Subject: Issuance of Amendment No. 21 to Facility Operating License
No. DPR-79 - Sequoyah Nuclear Plant, Unit 2

SEQUOYAH NUCLEAR PLANT, UNIT 2

AMENDMENT TO FACILITY OPERATING LICENSE

Amendment No. 21
License No. DPR-79

FIGURE 3.2-1

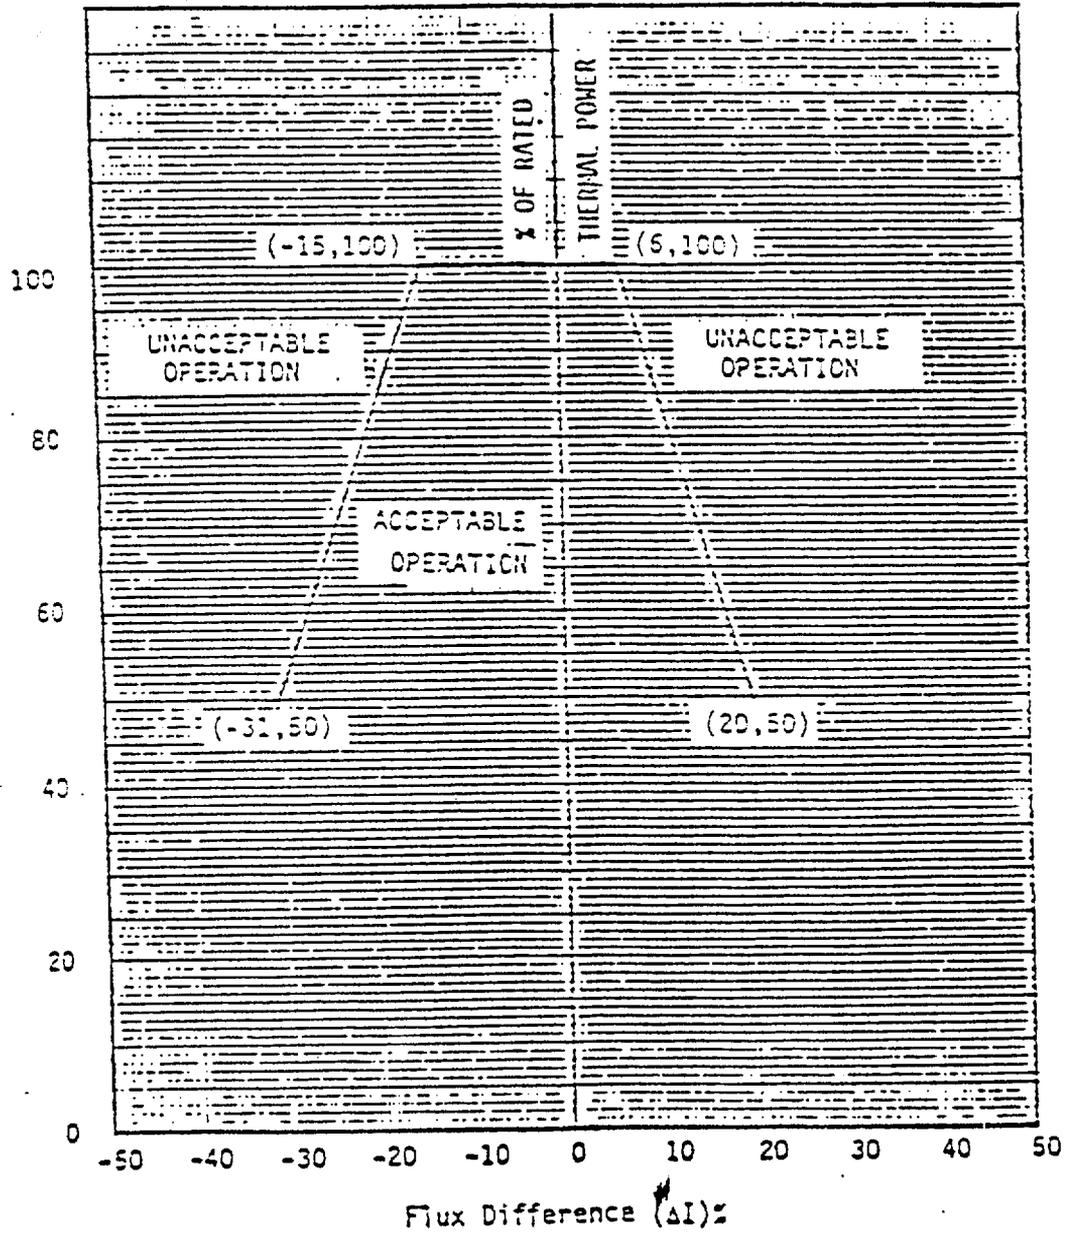
3.2.1 The indicated AXIAL FLUX DIFFERENCE (AFD) shall be maintained within the allowed operational space defined by Figure 3.2-1.

- a. With the indicated AXIAL FLUX DIFFERENCE outside of the Figure 3.2-1 limits;
 1. Either restore the indicated AFD to within the Figure 3.2-1 limits within 15 minutes, or
 2. Reduce THERMAL POWER to less than 50% of RATED THERMAL POWER within 30 minutes and reduce the Power Range Neutron Flux-High Trip setpoints to less than or equal to 55 percent of RATED THERMAL POWER within the next 4 hours.
- b. THERMAL POWER shall not be increased above 50% of RATED THERMAL POWER unless the indicated AFD is within the Figure 3.2-1 limits.

FIGURE 3.2-3 RCS Total Flowrate Versus R_1 and R_2 - Four Loops in Operation

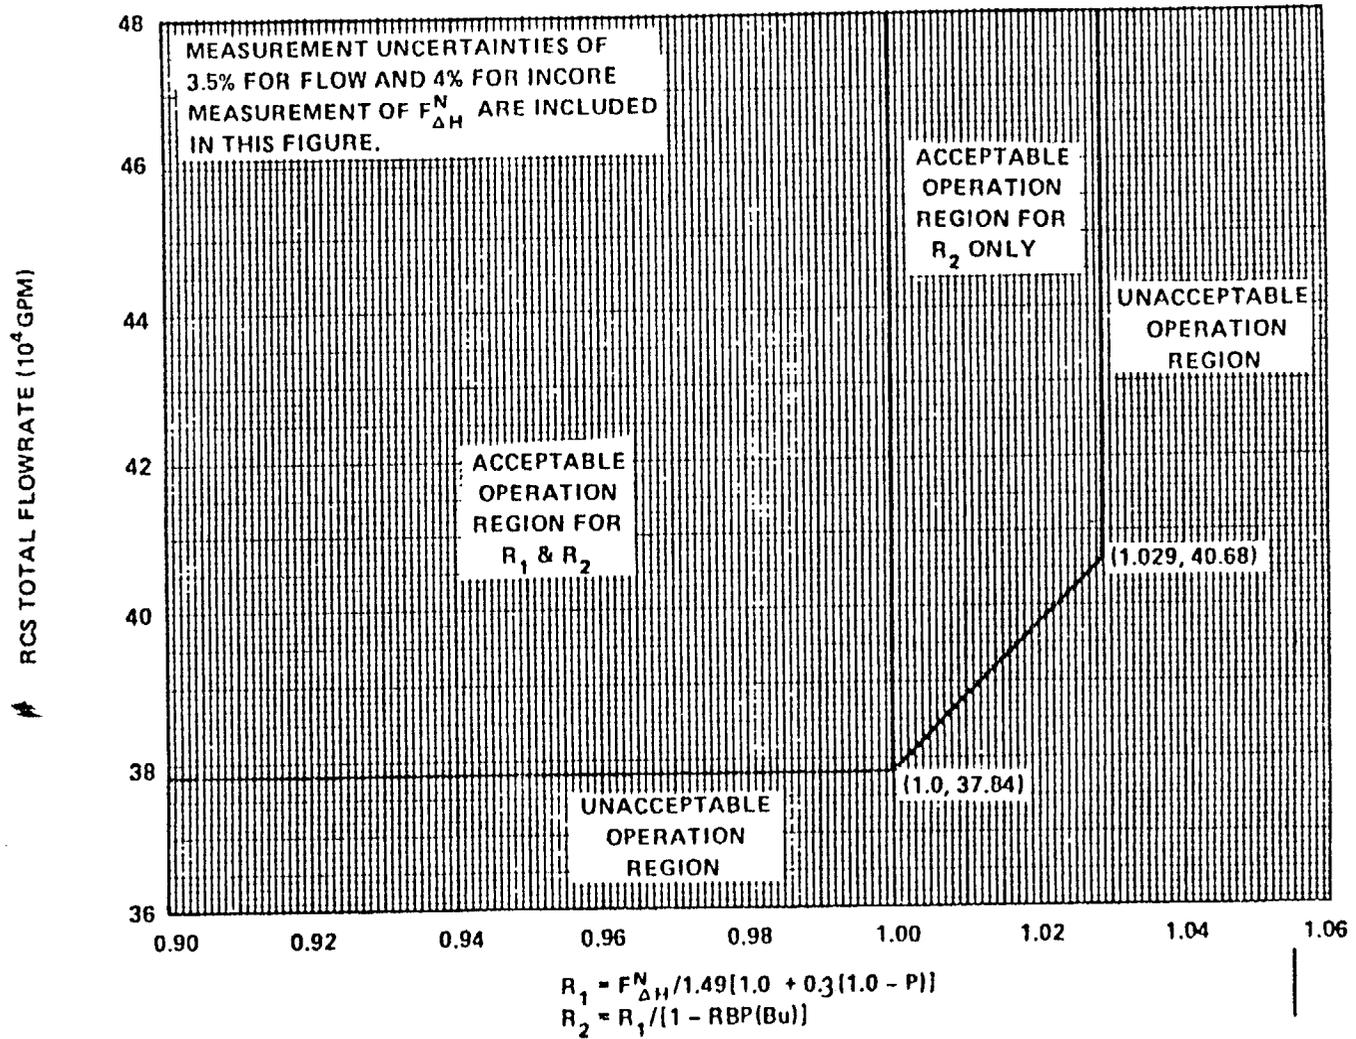
3.2.3 The combination of indicated Reactor Coolant System (RCS) total flow rate and R_1 , R_2 shall be maintained within the region of allowable operation shown on Figure 3.2-3 for 4 loop operation.

With the combination of RCS total flow rate and R_1 , R_2 outside the region of acceptable operation shown on Figure 3.2-3:
